# Access Compliance Report

## Public Rights-of-Way

Intersection ID: 42988	Main Street: UNIVERSITY_CITY_BV	Cross Street: UNIVERSITY_WALK_CR	Location: NW
ADA ID: ED3CD245E7FA	Ramp Type: Perp	Initial Pass/Fail: Fail	Overall Compliance: No
Severity Score: 26.25			
Codes/Mitigation Info/Possible Solution		Field Measurements/Component Compliance

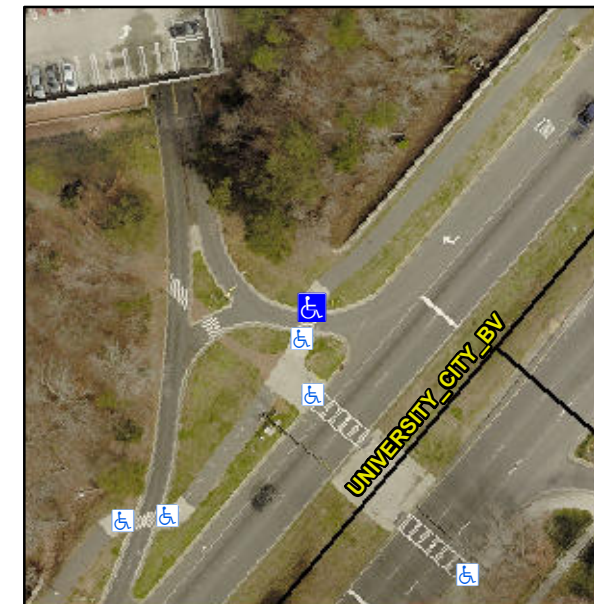
**Not Found, R304.2.2**

Compliance	Description	Data	Compliance	Description	Data
N/A	Ramp Length (in)	36.0	No	Ramp Slope (%)	16.3
Yes	Ramp Width (in)	122.0	Yes	Ramp XSlope (%)	3.7
N/A	Flare Type LT	N/A	N/A	Flare Type RT	N/A
N/A	Flare Slope LT (%)	N/A	N/A	Flare Slope RT (%)	N/A
N/A	Flare Traversable LT?	N/A	N/A	Flare Traversable RT?	N/A
N/A	Landing Length (in)	N/A	N/A	DWS Provided?	N/A
N/A	Landing Width (in)	N/A	N/A	DWS Contrast?	N/A
N/A	Landing Slope (%)	N/A	N/A	DWS Length (in)	N/A
N/A	Landing X Slope (%)	N/A	N/A	DWS Full Width?	N/A
N/A	Landing Curb? (Y/N)	N/A	N/A	DWS Offset (in)	N/A
N/A	Shared Landing?	N/A			
N/A	Gutter Ponding?	N/A	N/A	Gutter Slope (%)	N/A
N/A	Gutter Lip Ht (in)	N/A	N/A	Gutter X Slope (%)	N/A
N/A	Painted X Walk1?	Yes	N/A	Painted X Walk2?	N/A
	X Walk 1 Direction	To SW		X Walk 2 Direction	N/A
N/A	X Walk 1 Width (in)	95.0	N/A	X Walk 2 Width (in)	N/A
	X Walk 1 Slope (%)	9.9		X Walk 2 Slope (%)	N/A
	X Walk 1 X Slope (%)	3.8		X Walk 2 X Slope (%)	N/A

**Remove & Replace Entire Ramp.**
